CITY PLAN COMMISSION STAFF REPORT

Project Name
MC 106 Data Center

Request
CD-CPC-2023-00016
Development Plan

Report Date: April 27, 2023

NOTE: SEE SHEET L100 FOR FULL PLANT SCHEDULE.

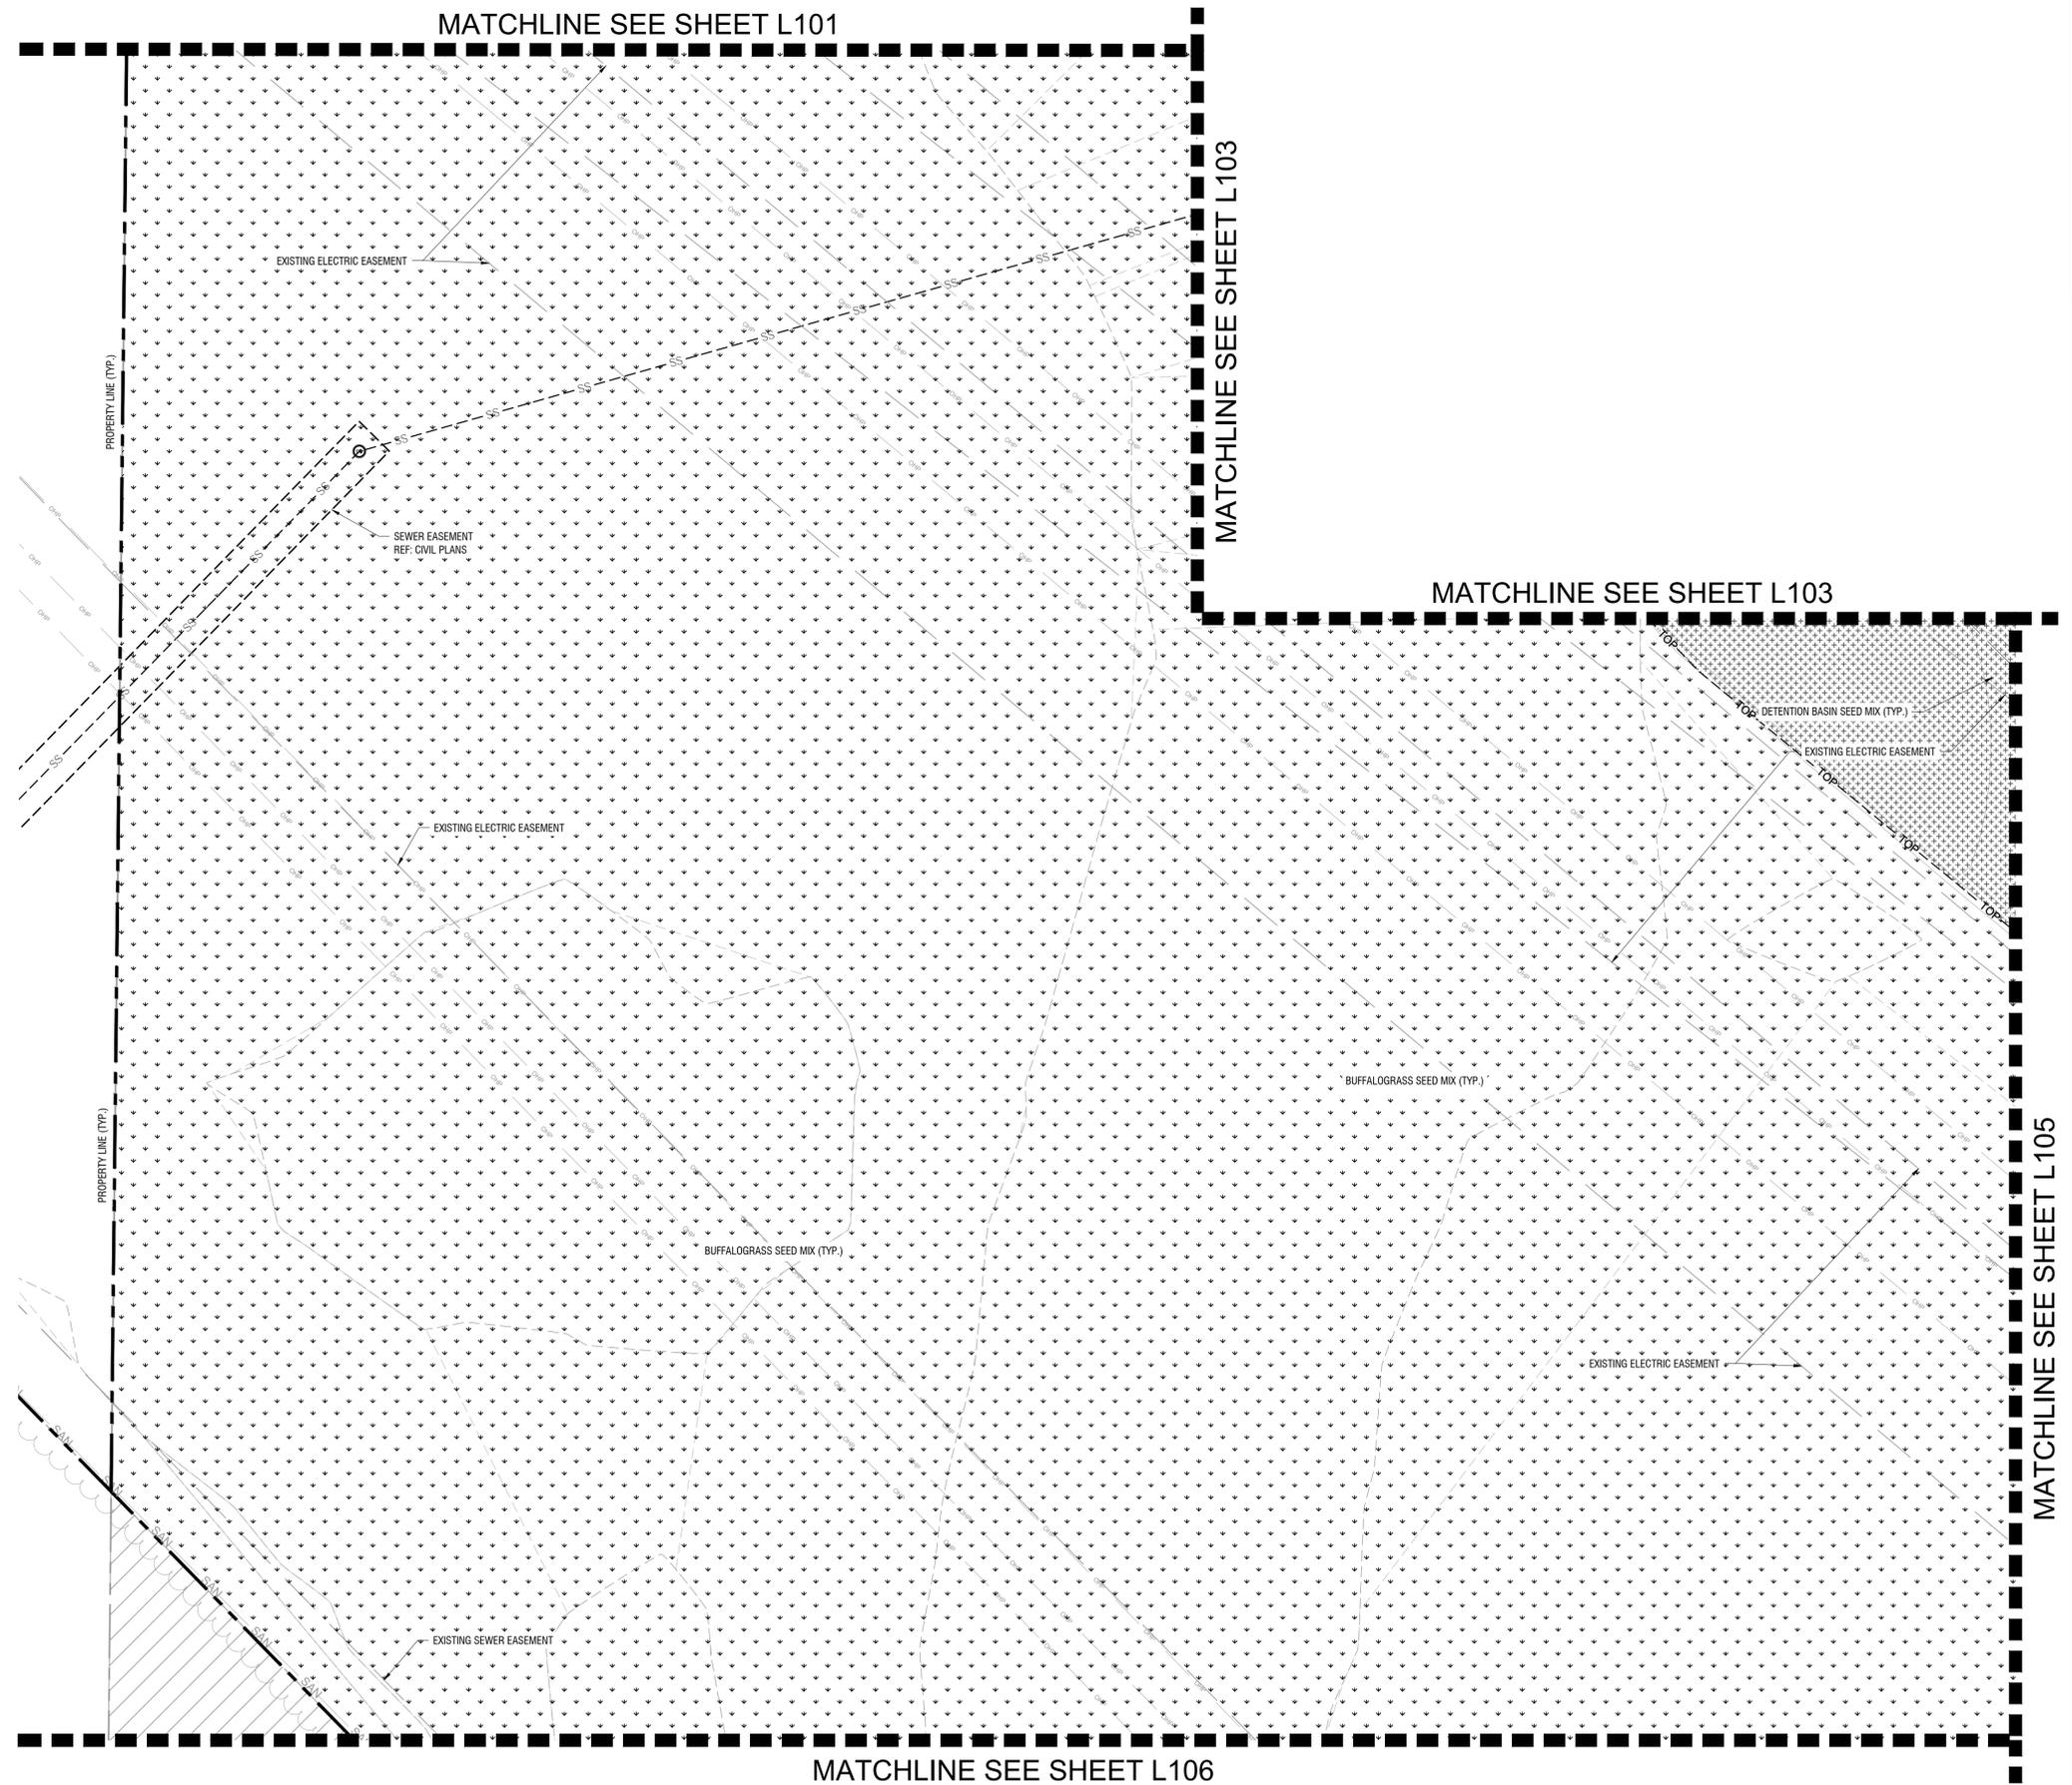
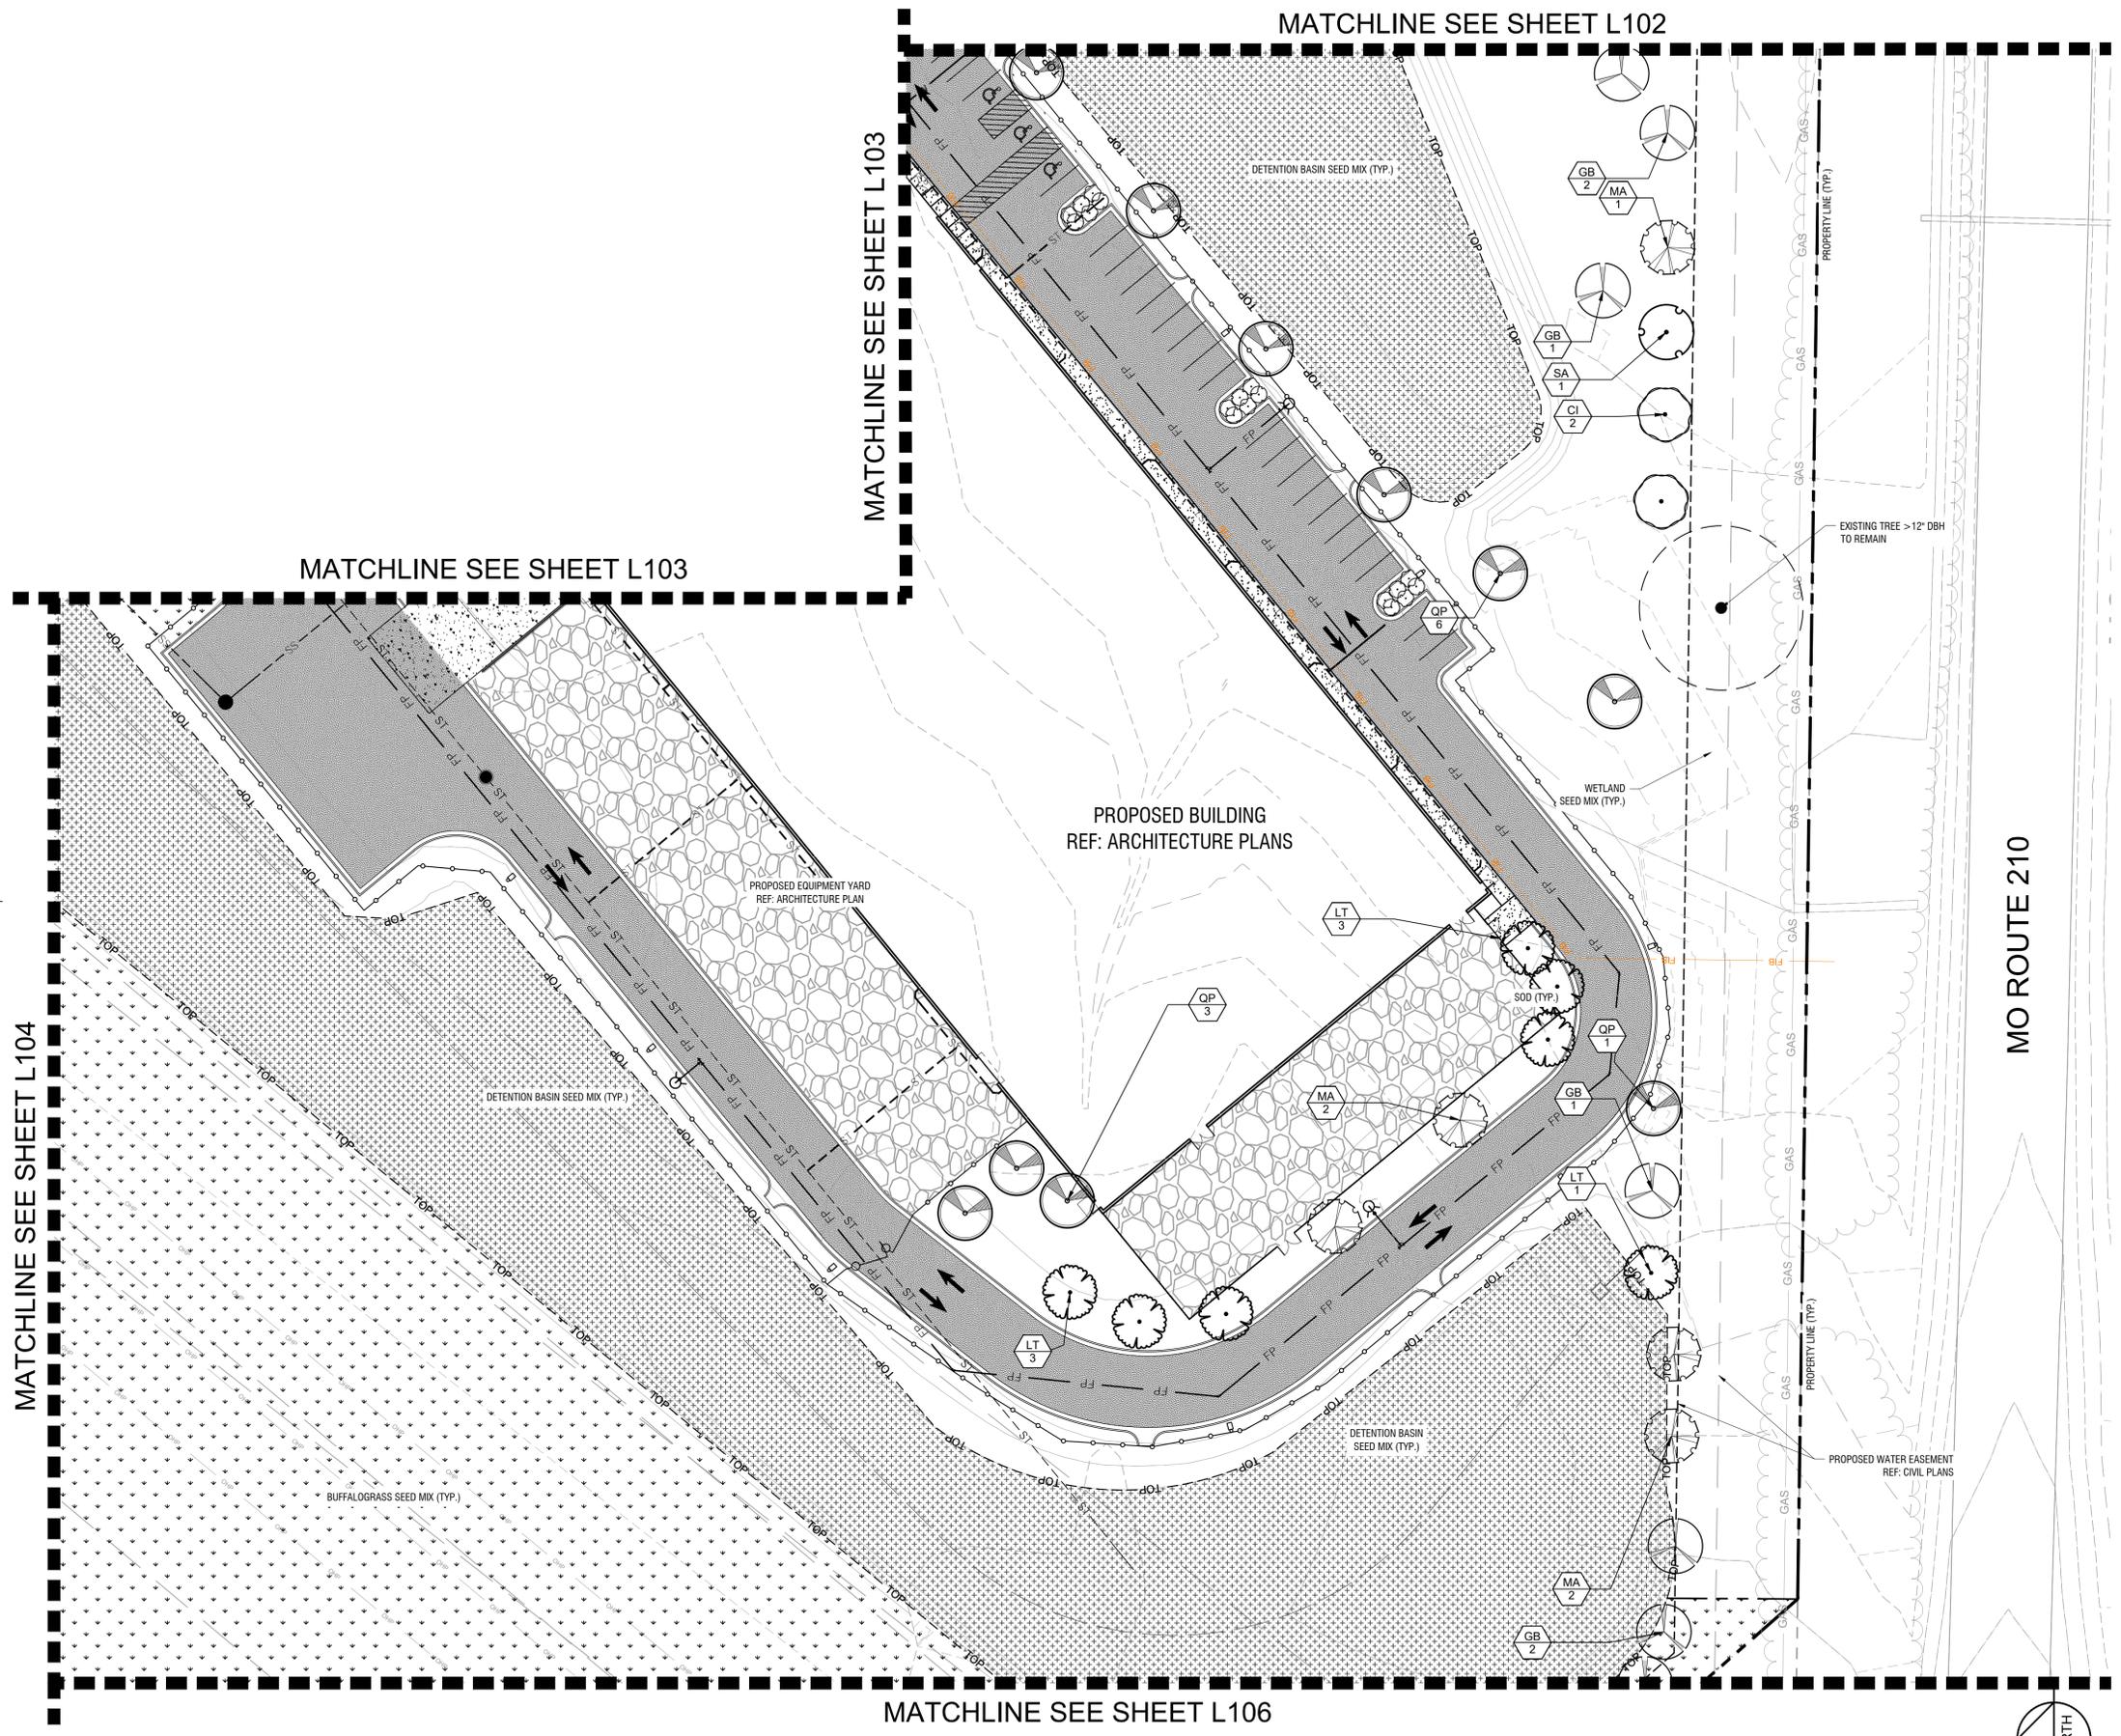
1. Submit evidence of approval by MoDOT prior to ordinance request.
 2. Revise the landscaping plan to show a berm and continuous row of evergreen shrubs along N. Arlington Avenue to screen the existing residences on the east side of N. Arlington Avenue per staff approval prior to ordinance request (4/17/2023)
